From: [REDACTED]
To: [REDACTED]
CC: [REDACTED]
Sent: 3/23/2021 4:49:34 PM
Subject: RE: O8W-PM [REDACTED] - Bucks Creek 1101 Phase 1,2&3 - Pre-Engineering Meeting

Bucks Creek 1101- PM# [REDACTED] Overview Map

Subject: O8W-PM [REDACTED] - Bucks Creek 1101 Phase 1,2&3 - Pre-Engineering Meeting

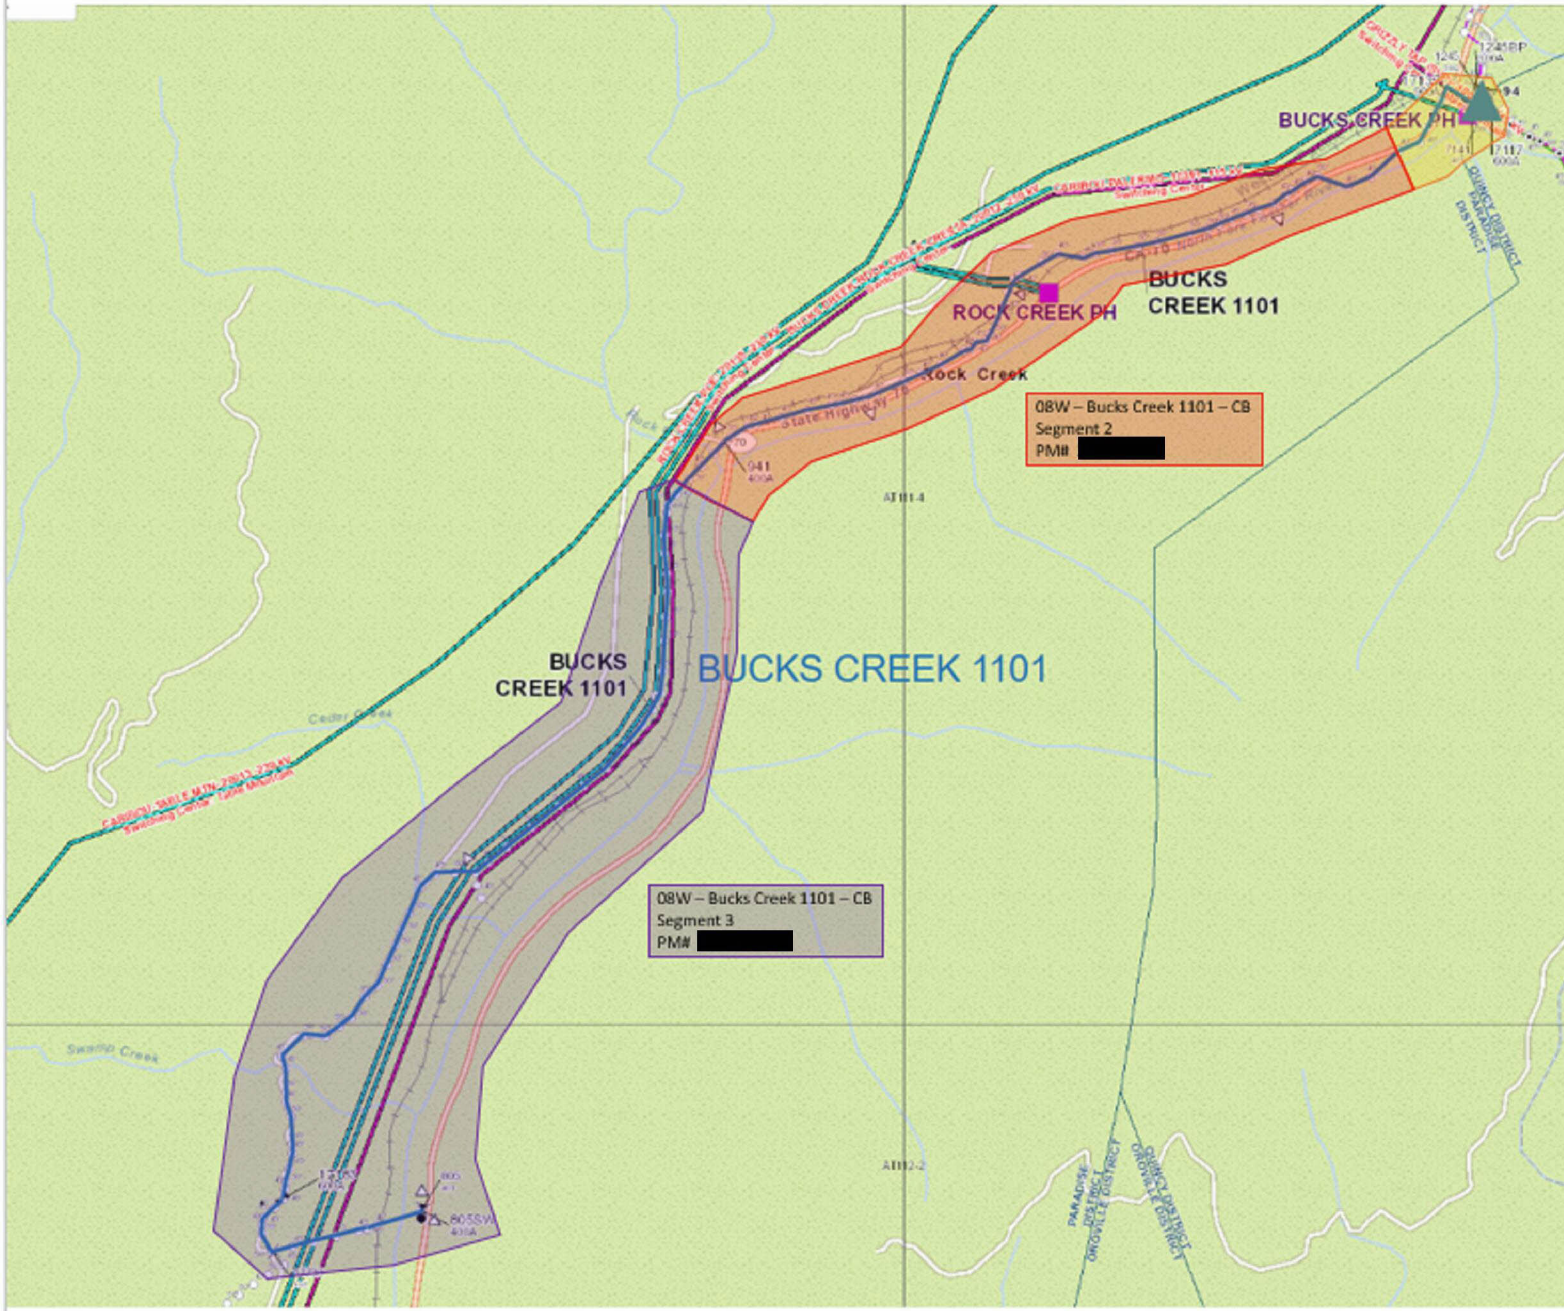
Attached are the 'base-map' limits in a kmz. file. As you will see, we need our base-map to go about ~100' into the tunnel at the south end (see pedestal in picture below....please begin about ~50 beyond this point which is about ~100' beyond the Cresta Dam).

We want to end the base-map at the sign location below which is roughly at MM (Mile Marker) 5.10.
